Access Compliance Report

Public Rights-of-Way

(Curb Ramps)

Intersection ID: 11838	Main Street: MECKLENBURG_AV	Cross Street: FORT_ST	Location: E
ADA ID: 1D11EA636C57	Ramp Type: Directional1	Initial Pass/Fail: Pass	Overall Compliance: No
Codes/Mitigation Info/Possible Solution		Field Measurements/Component Compliance	
Severity Score: 0.25

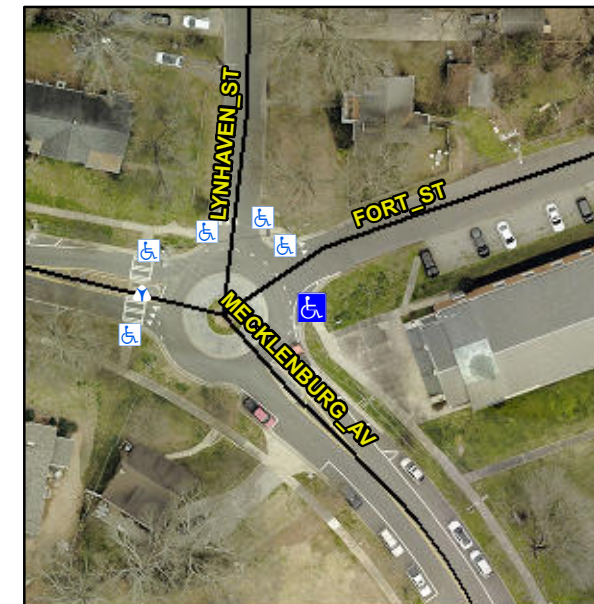
R304.5.3, R304.2.2-Perp, R304.3.2-Para

Compliance	Description	Data	Compliance	Description	Data
N/A	Ramp Length (in)	123.0	Yes	Grade Break?	Yes
Yes	Ramp Width (in)	59.0	Yes	Grade Break Slope (%)	0.7
Yes	Ramp Slope (%)	1.6	No	Grade Break XSlope (%)	4.4
No	Ramp XSlope (%)	3.5			
Yes	Flare Type LT	N/A	Yes	Flare Type RT	N/A
N/A	Flare Slope LT (%)	N/A	N/A	Flare Slope RT (%)	N/A
N/A	Flare Traversable LT?	No	N/A	Flare Traversable RT?	No
Yes	Landing Length (in)	70.0	Yes	DWS Provided?	Yes
Yes	Landing Width (in)	59.0	Yes	DWS Contrast?	Yes
No	Landing Slope (%)	2.8	Yes	DWS Length (in)	24.0
Yes	Landing X Slope (%)	0.5	Yes	DWS Full Width?	Yes
N/A	Landing Curb? (Y/N)	No	Yes	DWS Offset LT (in)	51.0
N/A	Shared Landing?	No	Yes	DWS Offset RT (in)	2.0
Yes	Gutter Ponding?	No	Yes	Gutter Slope (%)	4.8
Yes	Gutter Lip Ht (in)	0.0	No	Gutter X Slope (%)	3.5
N/A	Painted X Walk1?	No		Road Slope (%)	3.2
	X Walk 1 Direction	To NW		Road X Slope (%)	1.0
	X Walk 1 Width (in)	N/A		Clear Space?	Yes

X Walk 1 Slope (%)	3.2	N/A	Clear Space to XWalk (in)	N/A
	X Walk 1 X Slope (%)	1.0	Yes	Storm Grate/Utility Hazard?	No
N/A	Ramp inside XWalk1?	N/A		Storm Grate/Utility Type	
Yes	Any Obstructions?	No			N/A
	Obstruction Type		Yes	Surface Condition? (G/P)	Good
			N/A	Curb Slope (%)	3.0

**Remove & Replace Entire Ramp.
Remove & Replace Gutter.**
